LIDAR 2002 Quality Assurance Report

Authored by Dewberry LLC
2004

The initial review of the Worcester County LIDAR data flown in the summer of 2002 did not yield the results as required per contractual specifications. With either the standard Root Mean Square Error (RMSE) method or the modified RMSE method accepted by FEMA for Phase 1 of the North Carolina Floodplain Mapping Program (NCFMP), the dataset errors greatly exceeded the 18.5 cm RMSE errors expected for elevation datasets equivalent to 2 ft contours. Although the data did not meet specifications, it was clear that some of the data was in fact sufficient. This indicated that with further processing and analysis, the data could potentially meet the desired accuracy. This was ascertained by reviewing and analyzing the data not only on the whole of the dataset but by looking at each land cover category in great detail.

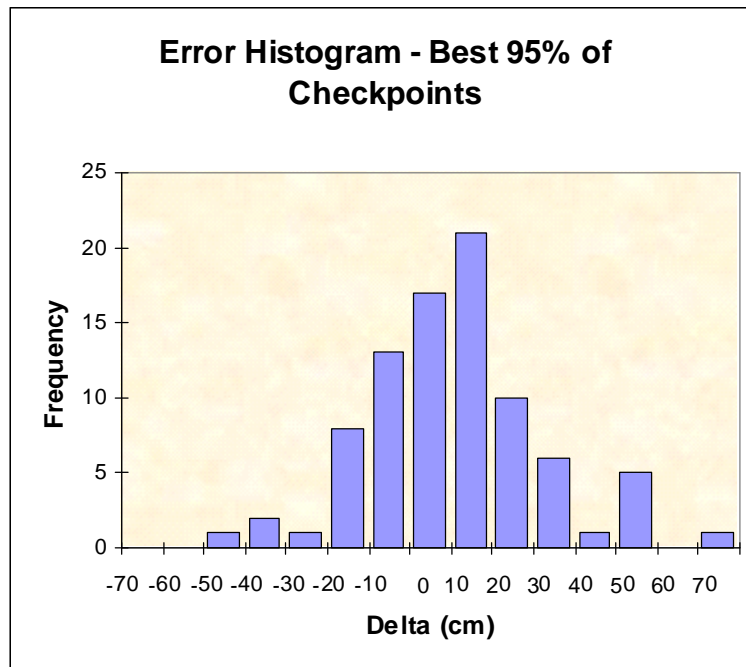
Figure 5 and Figure 6 illustrates the histogram of the associated delta errors between the interpolated LIDAR TIN and the survey checkpoint. It is interesting to note that the errors do not follow a normal distribution. Even when the 5% largest errors are removed, the errors still do not follow a normal distribution. With this scenario where some errors do not follow a normal distribution, invalidates the RMSE methodology, the NDEP recommends that alternative criteria be used to determine the Fundamental Vertical Accuracy (mandatory) and Supplemental and Consolidated Vertical Accuracies (optional).

Figure 5 – Error Histogram of the best 95% of data checkpoints. This illustrates that the errors do not follow a normal distribution even when the top 5% of outliers are removed, because there are nine outliers larger than 41.7 cm (1.9600 X RMSE) whereas there should only be four (actually 4.3) such outliers if errors had followed a normal distribution.

Figure 8 - Edge matching of TIN's between the re-flight area (top area) and the existing re-processed data (bottom area)

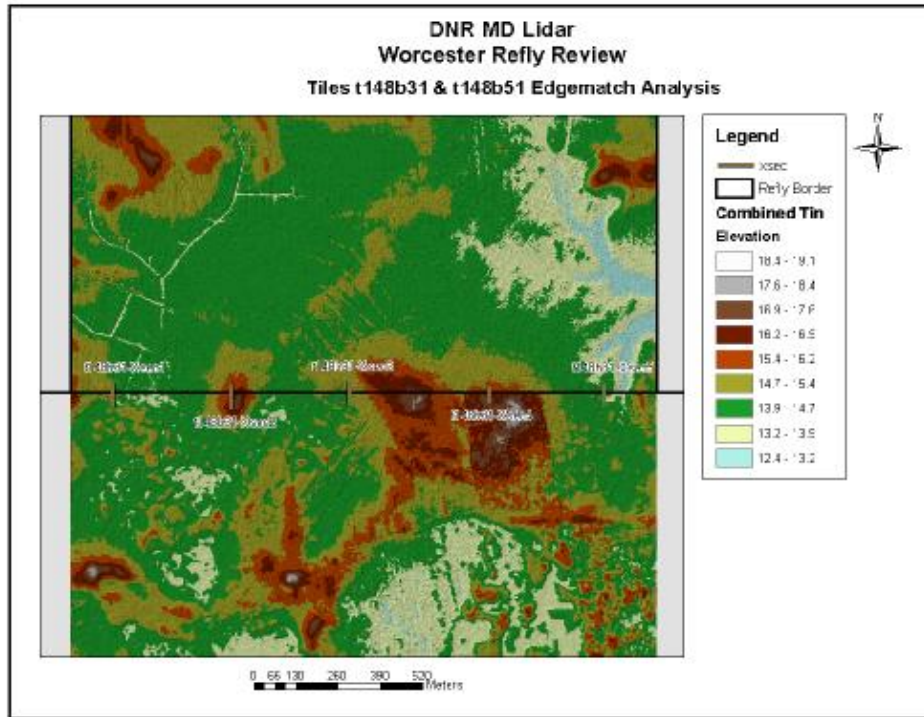
To assess the relative accuracy, TIN's were created for adjacent tiles from both the new and old data. The TIN's were visually inspected looking for anomalies that may indicate a vertical shift between the two data sets. Additionally hillshade and slope maps were created to aid in this process. The overall consistency of the new re-flight data contrasts slightly with the re-processed data due to the issues of the original sensor and the time of year the data was flown. The re-flight area was flown during leaf free conditions and with crops in their starting growth stage. Figure 8 illustrates the two adjacent TIN's and the locations of the cross sections. It can be noted that the re-fly area to the north indicates a smoother consistent terrain model. Figure 9 shows the slope between the adjacent TIN's, again showing the re-fly area to be more consistent.

Figure 10 – Cross sections between re-flight area and re-processed data

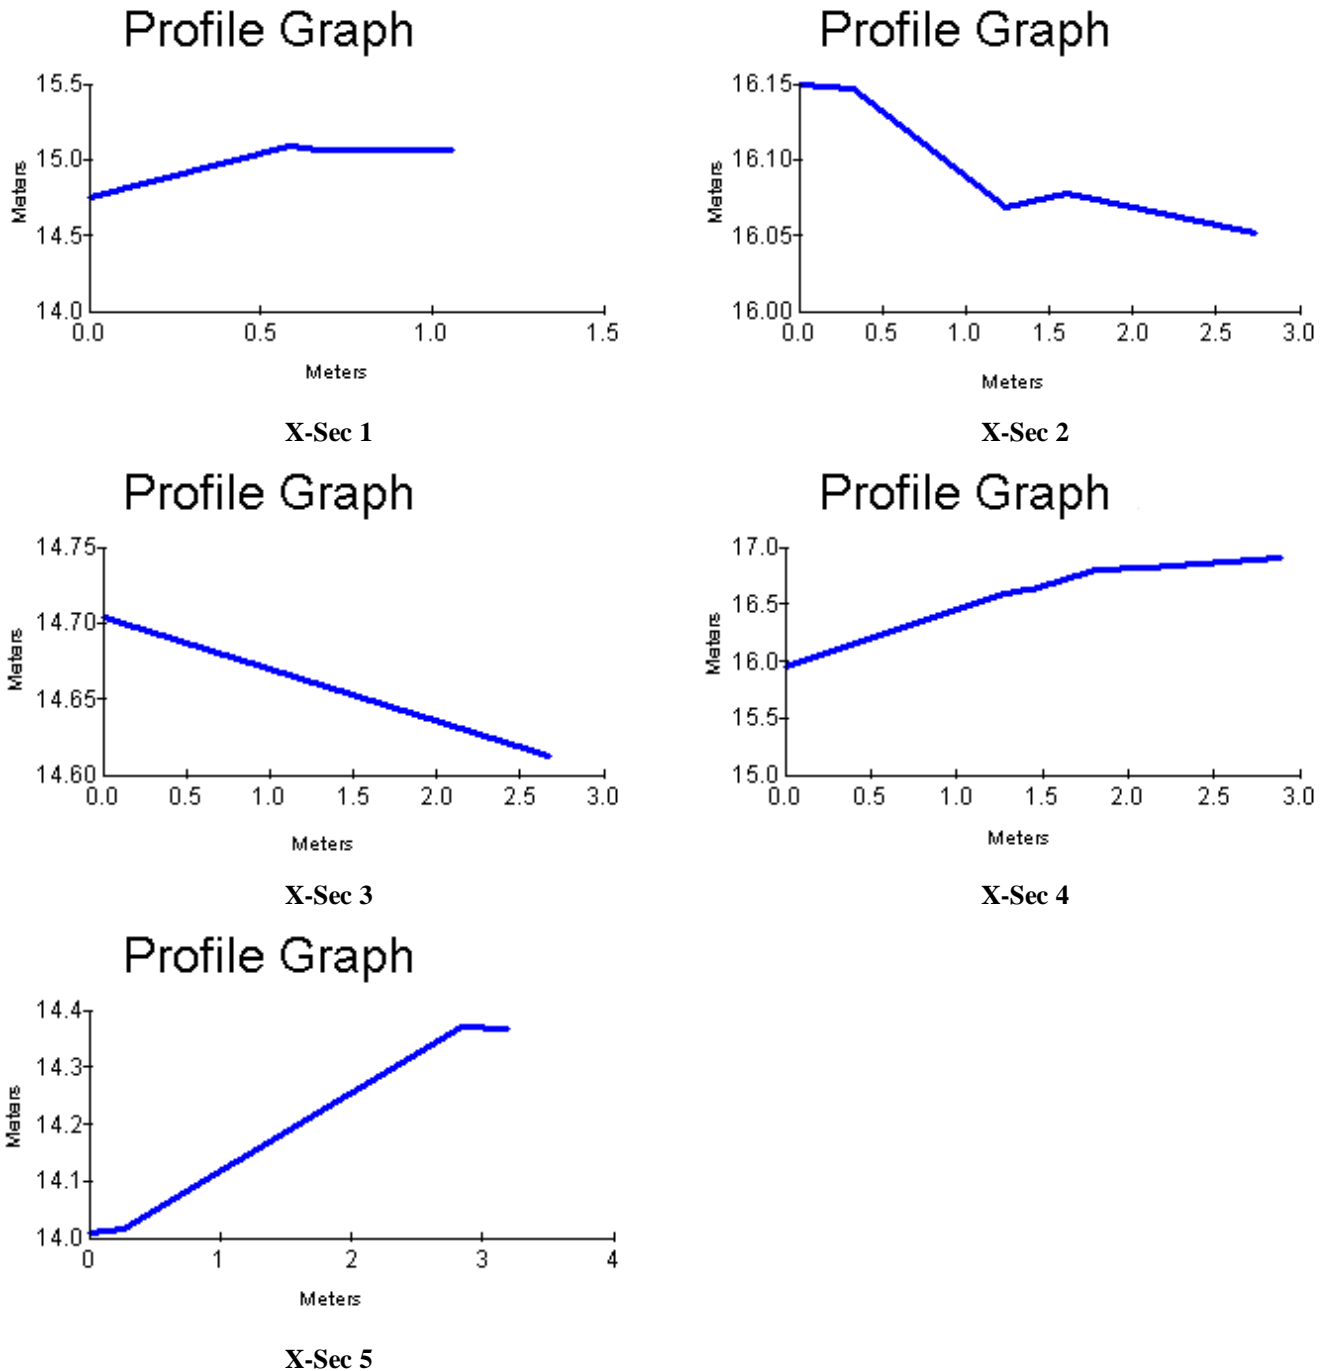
The graphs in Figure 10 illustrate cross sections (Figure 9 for locations) between the two dataset TIN's. Overall the data fits relatively well with a slight miss-matching between edges. In areas of gradual slope there are no apparent large vertical shifts but further analysis is recommended.

Figure 14 - TIN edges illustrating density and lack of density leading to data voids. The area in yellow is approximately 5.6 acres.

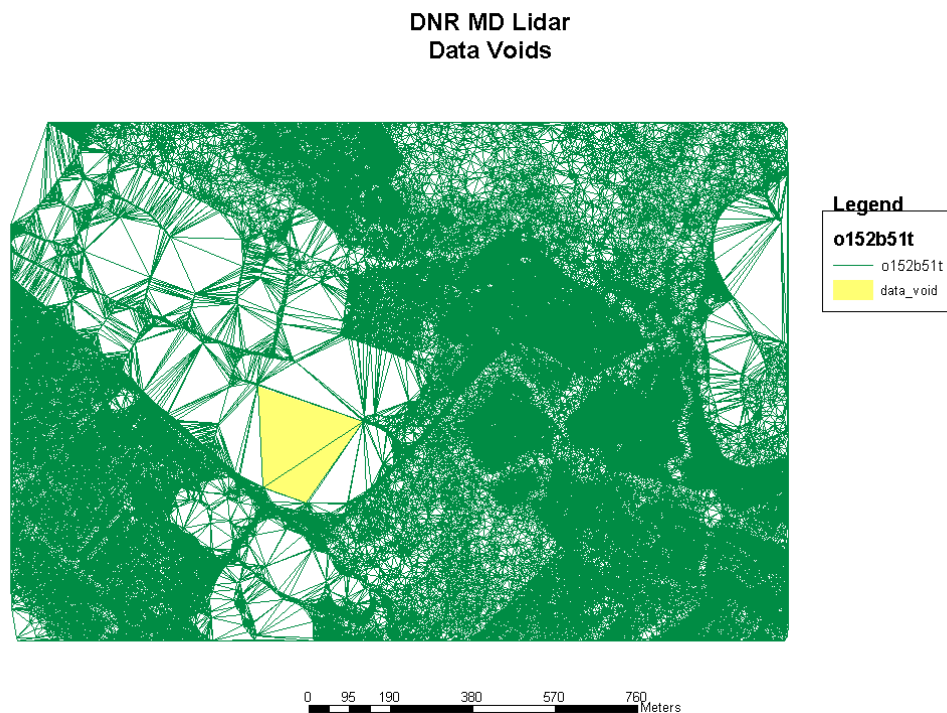
The areas of less data points are easily correlated to that of Weeds/Crop whereby the LIDAR had the most difficult time penetrating to the surface. This is especially true in the agricultural fields. In this scenario having less points may yield a better answer but it also introduces large data voids. In some areas these voids are quite large (>5 acres – Figure 14) and will have to be addressed on a product-need basis. This example identifies data voids but these voids are located in vegetated fields where hydraulic cross sections would normally not be located for flood studies. Since these fields are regularly plowed, it is safe to assume that they are relatively flat with slight modulations.

FEMA guidelines state; data voids may be acceptable if they are outside the floodplain and if interpolation methods can be used to fill the voids (i.e. hydrologic modeling). If the data void is within the floodplain where hydraulic modeling is performed, then the size and location will have a bearing on whether additional surveys will be required to fill the voids. In this scenario, voids greater than 1 acre where representative cross sections may need to be cut may need supplemented surveys unless other equally acceptable areas exist for cutting of representative cross sections. This decision process would normally include the FEMA Lead to decide if the additional costs are warranted or if the alternative methods are acceptable.

Figure 19 - Cross section locations to test stream channel geometry and "noise level" of LIDAR (Tile T151B31)

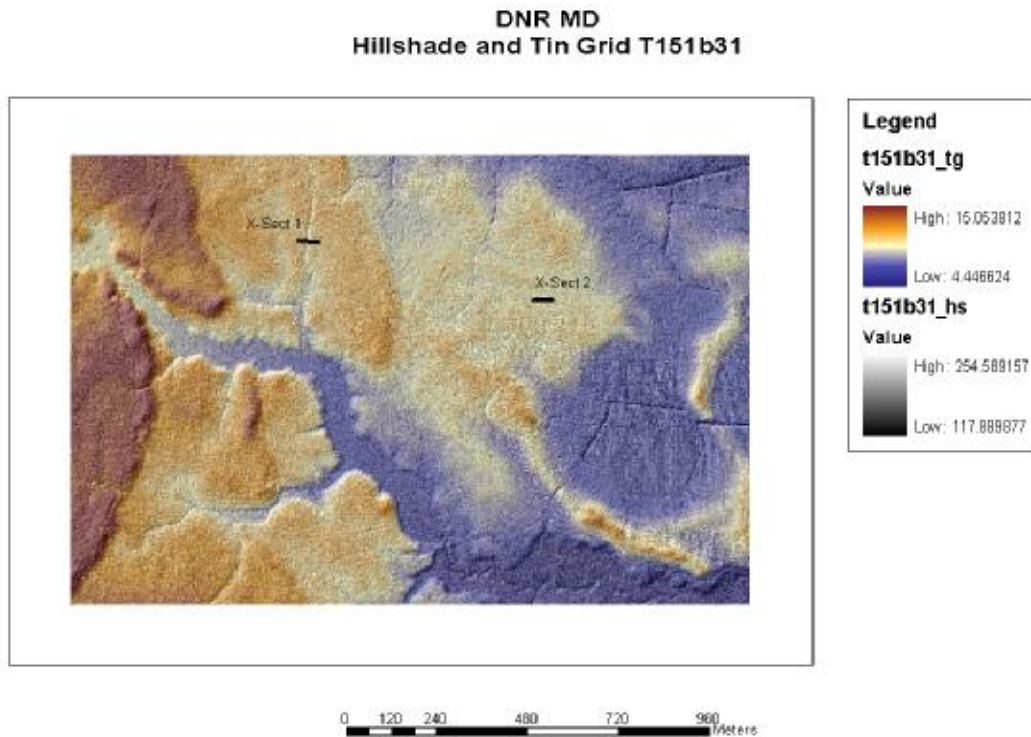
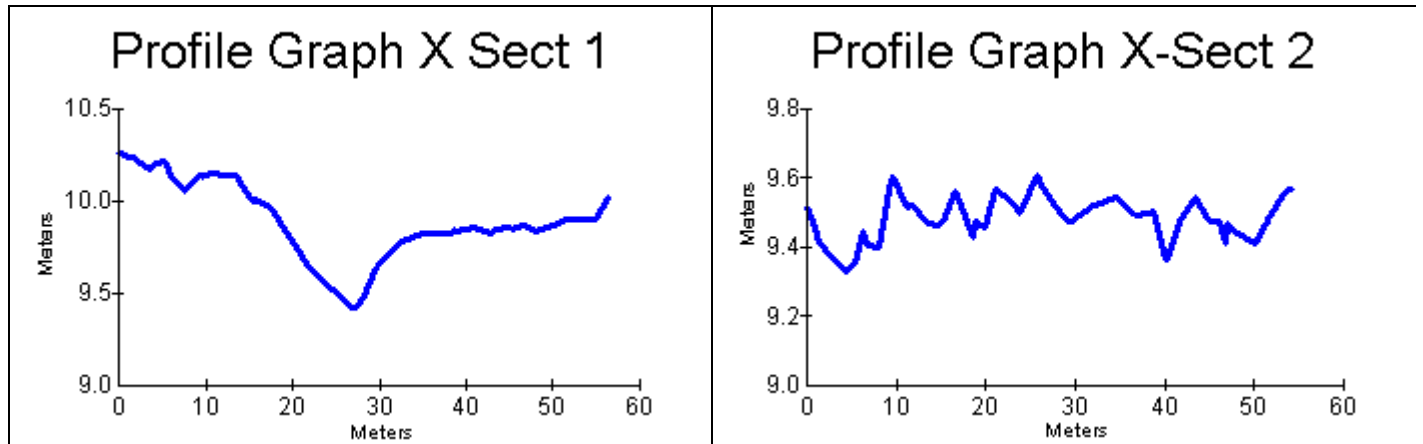
Figure 19 and Figure 20 reiterate the findings of the review of this data. The stream channels are clearly identified while the noise level is slightly elevated within the 15 cm level.
